LIBERTY HIGH SCHOOL Administration and Student Commons Modernization

Addendum 02

DECEMBER 21, 2020

Architect's Project No.: 1783.00

SHEET NUMBER ADDENDUM 02 A-B5.1

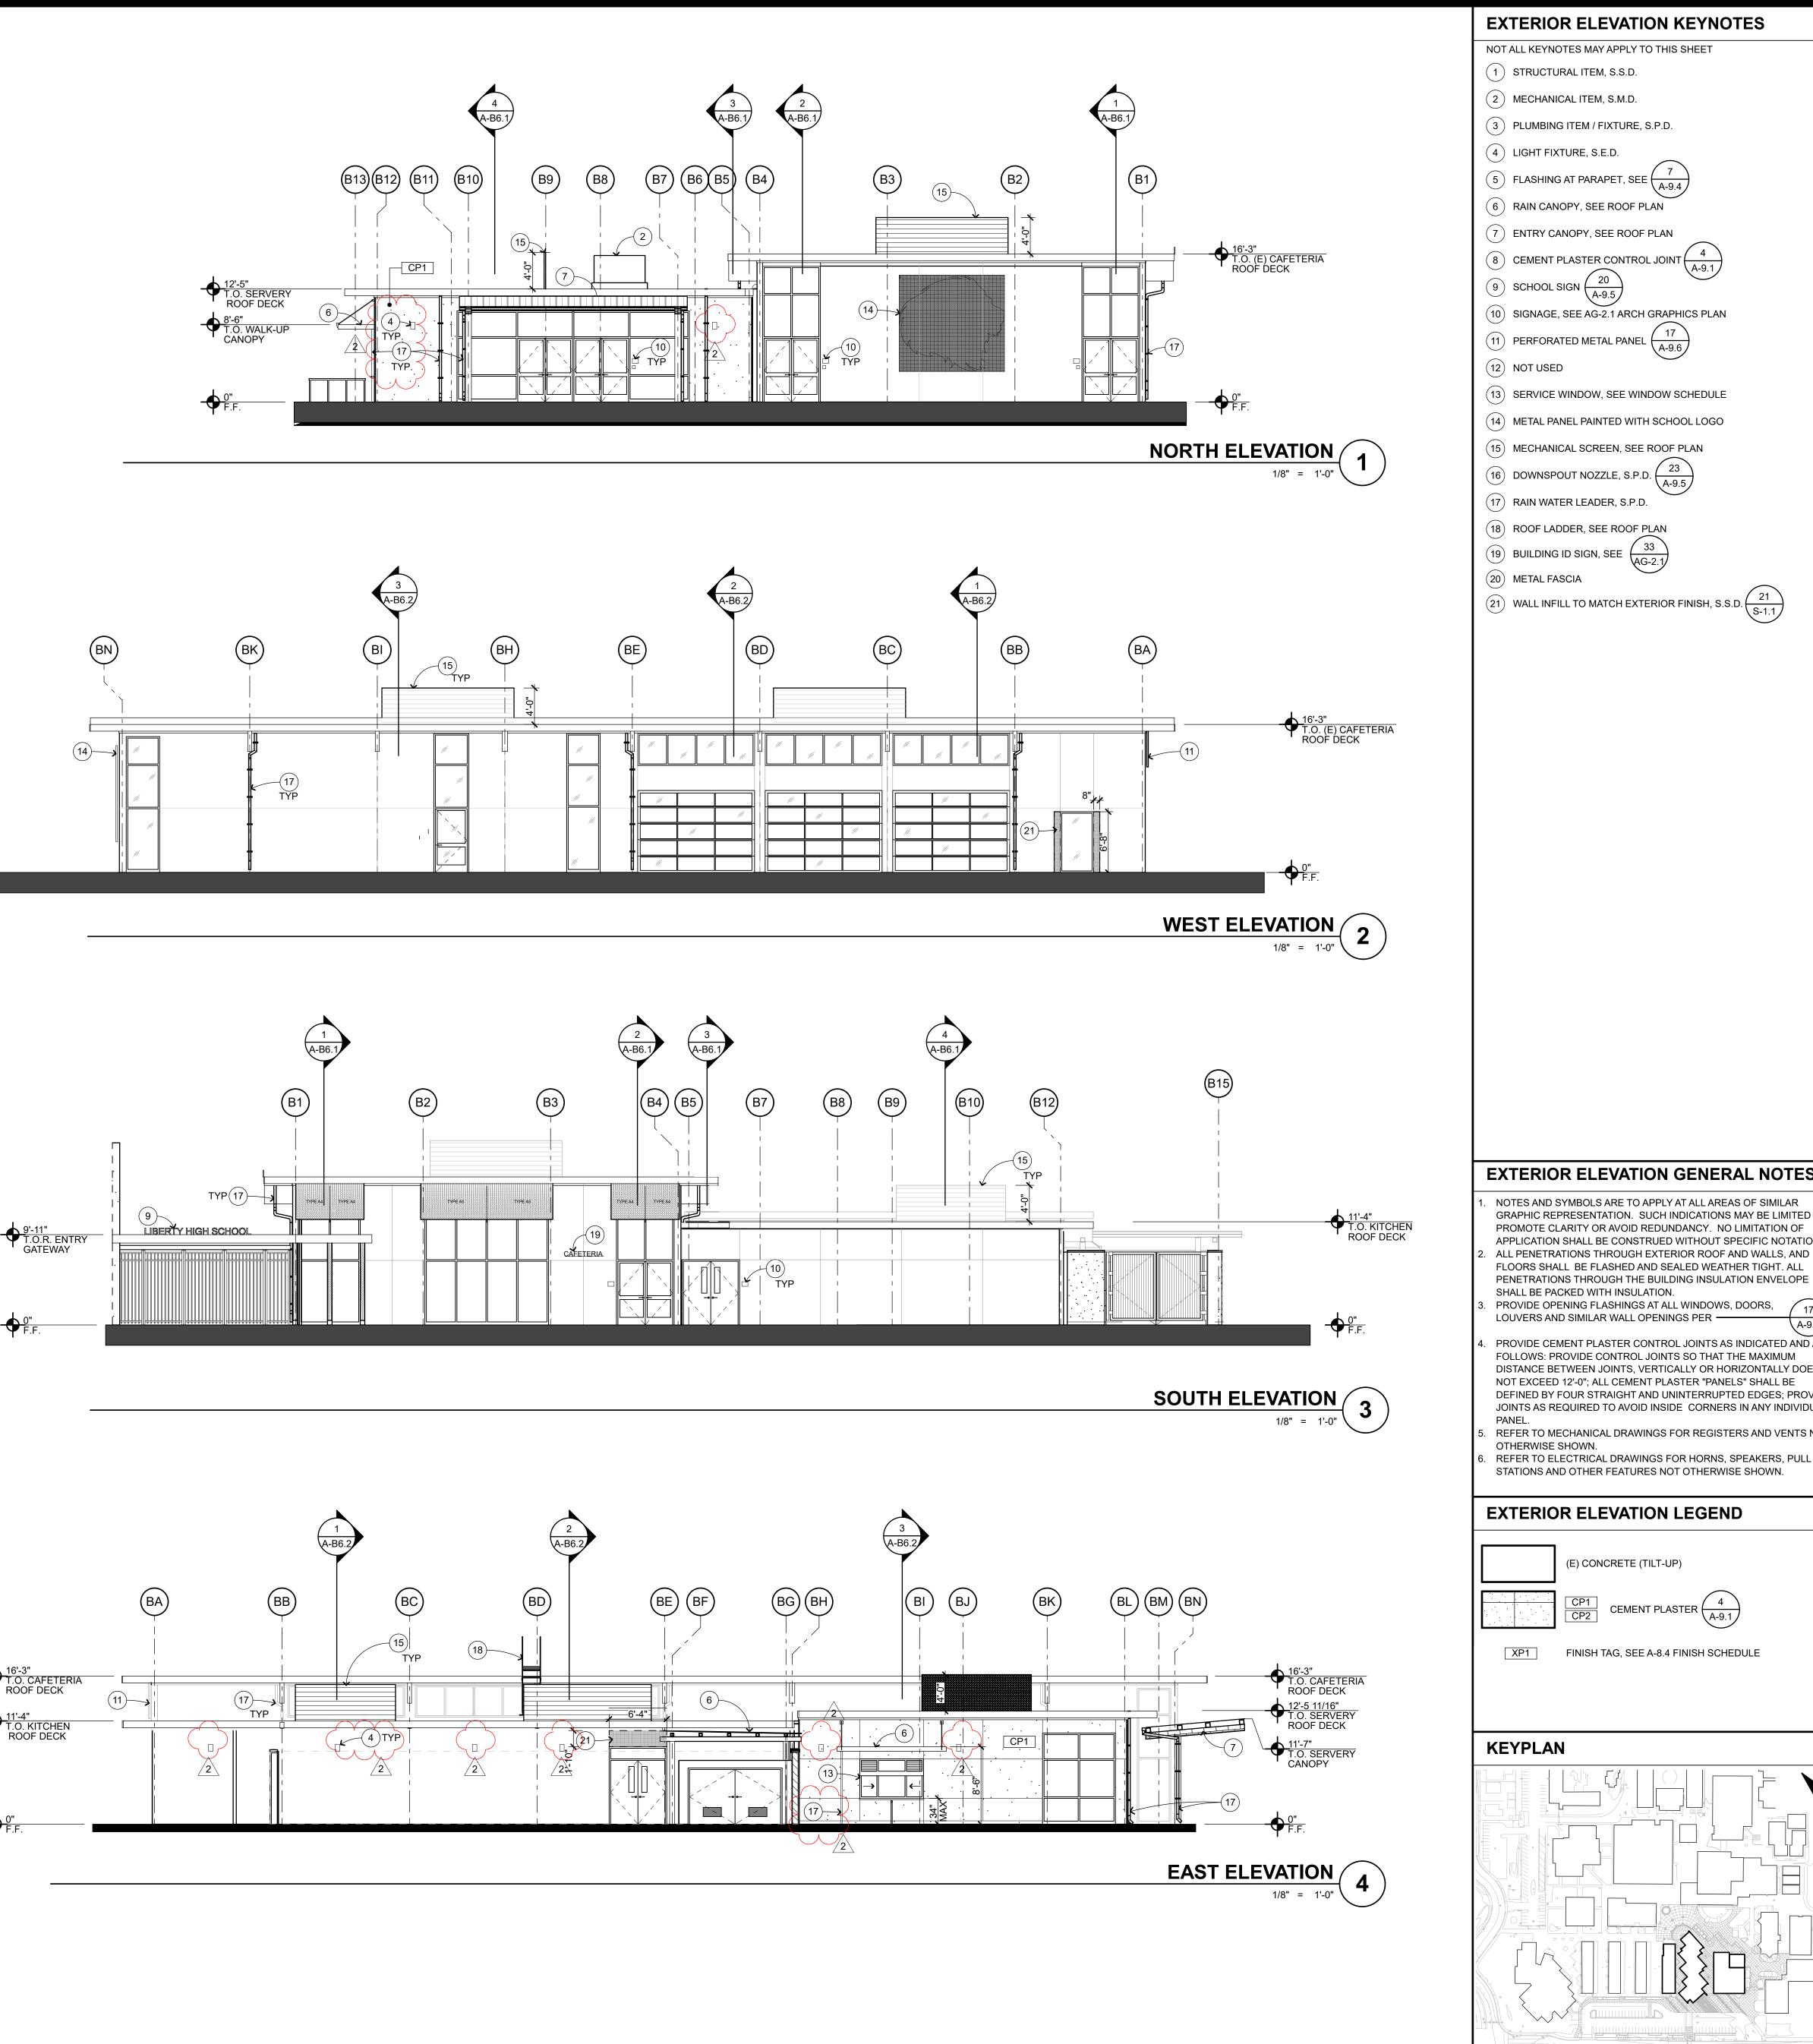
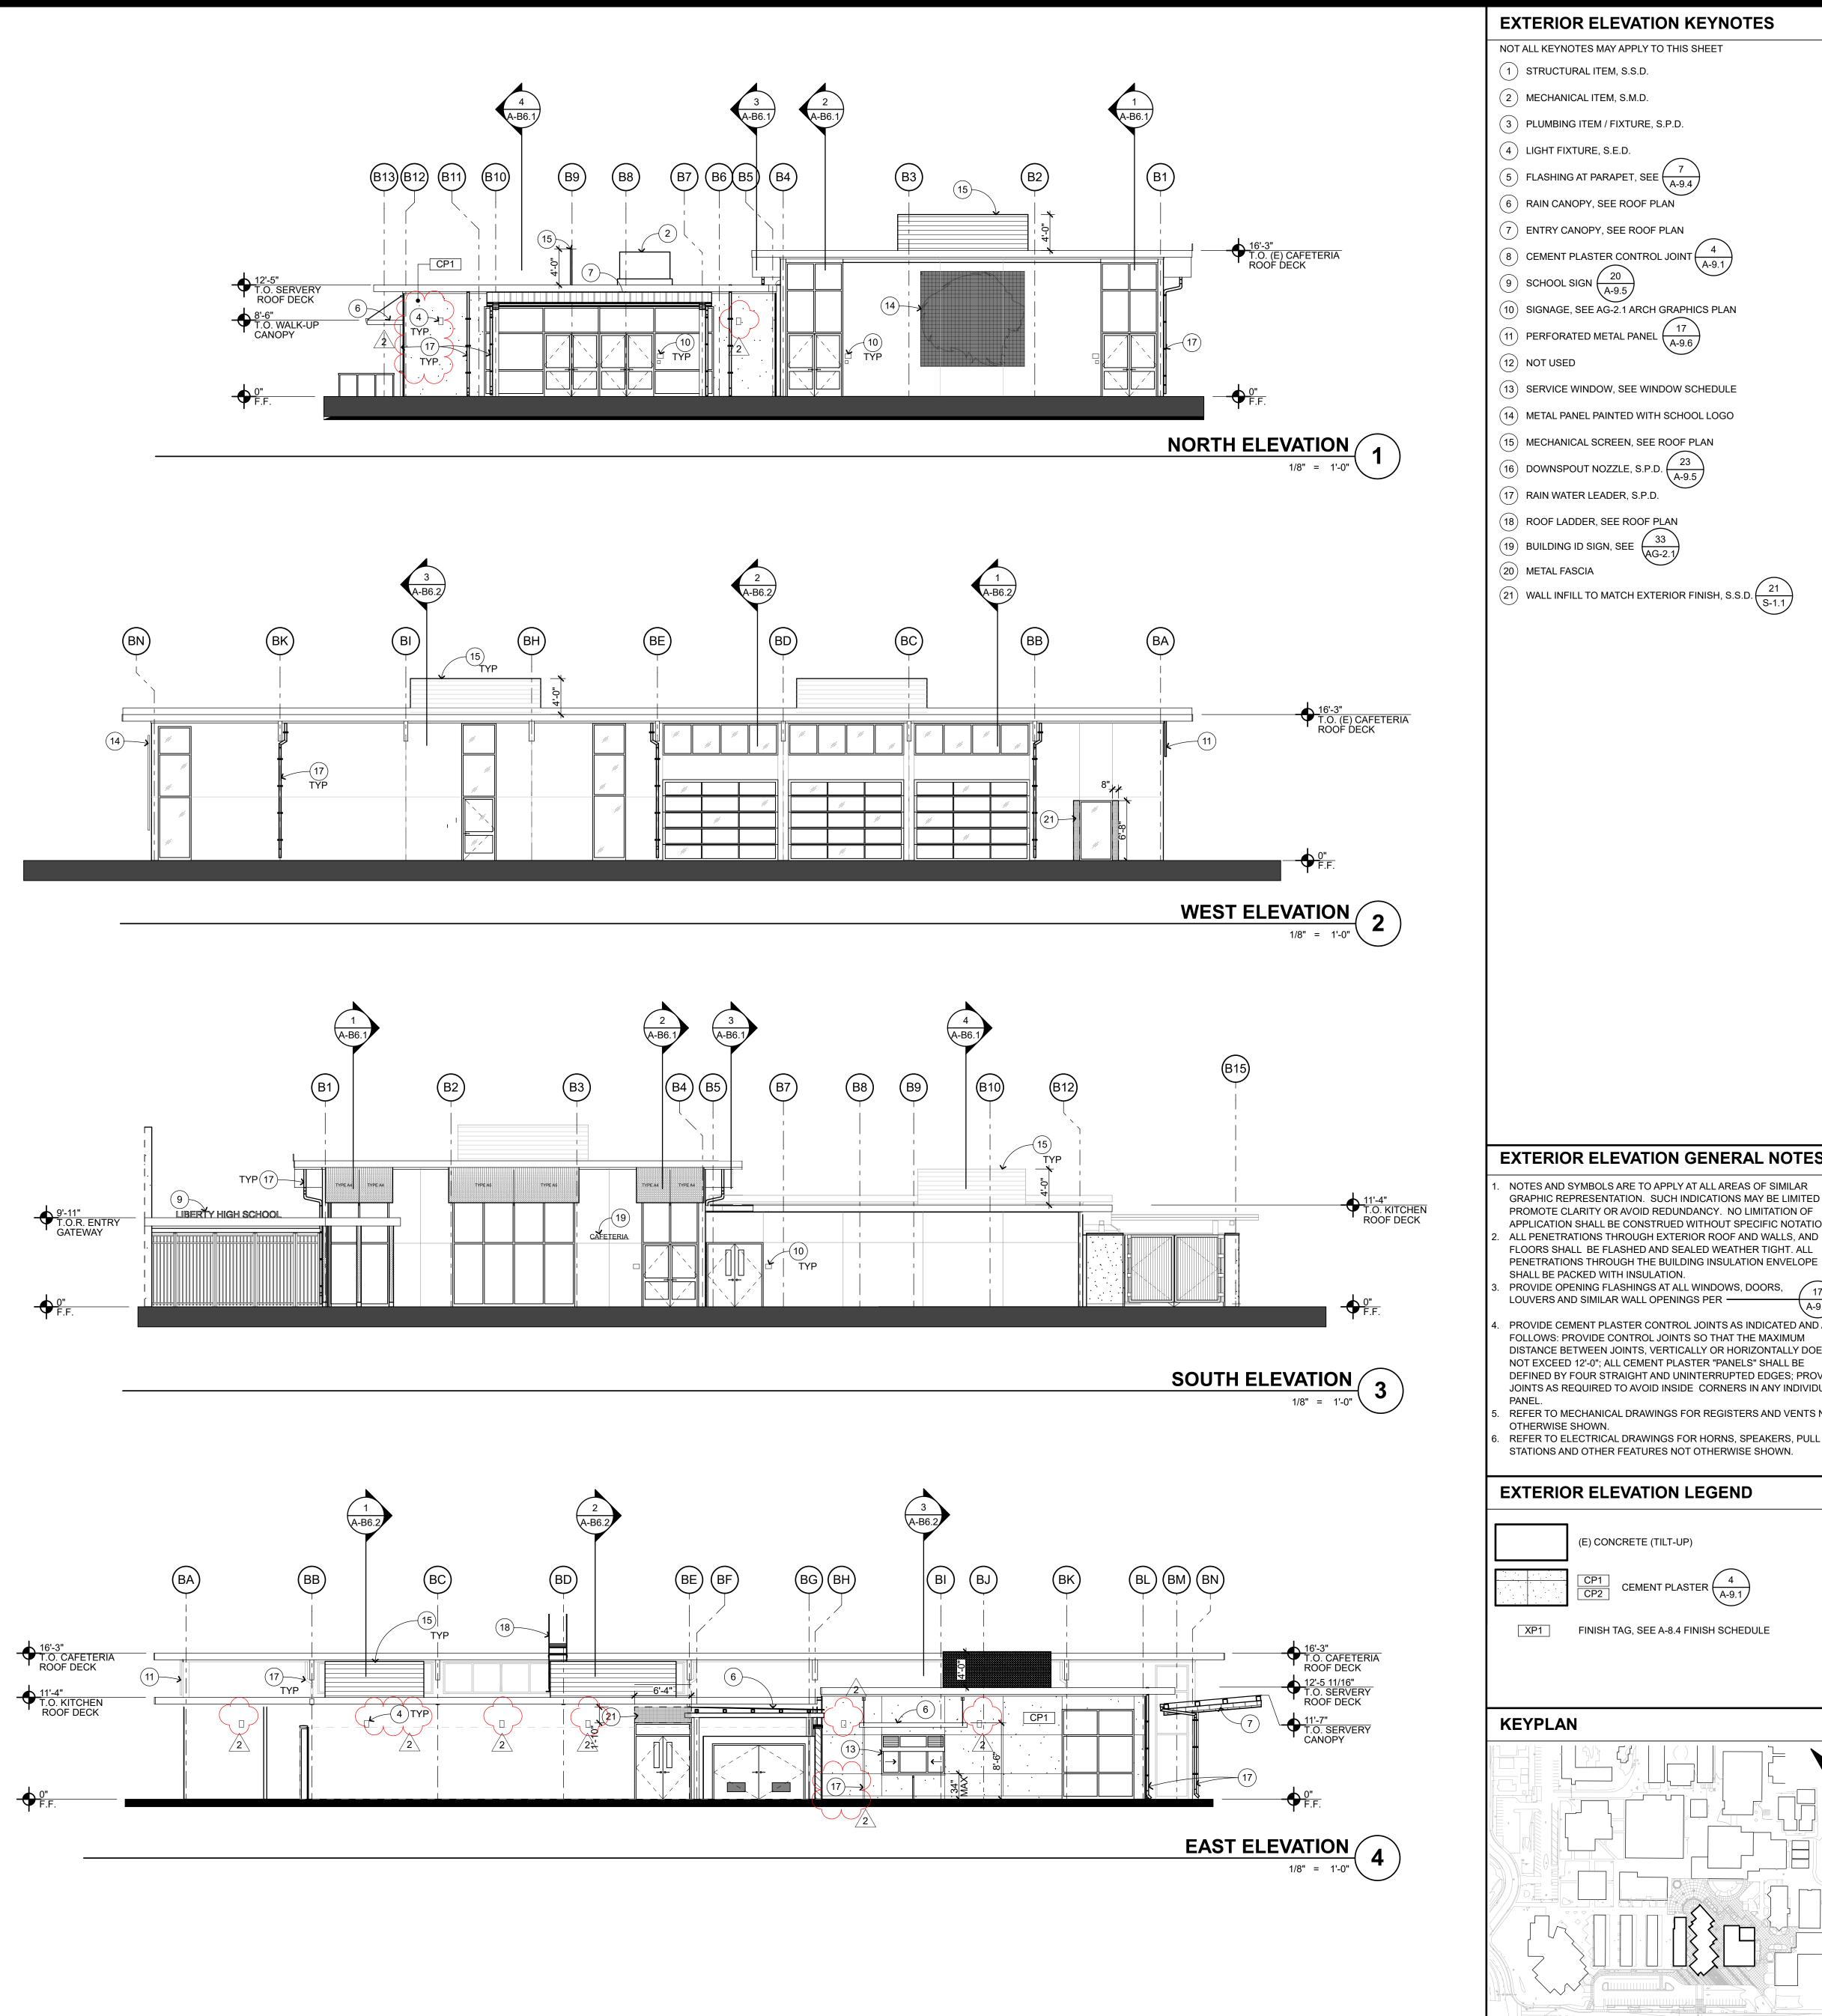
The following drawings dated December 18, 2020 denoted **Addendum 02** supersede and replace previous drawings with the same titles:
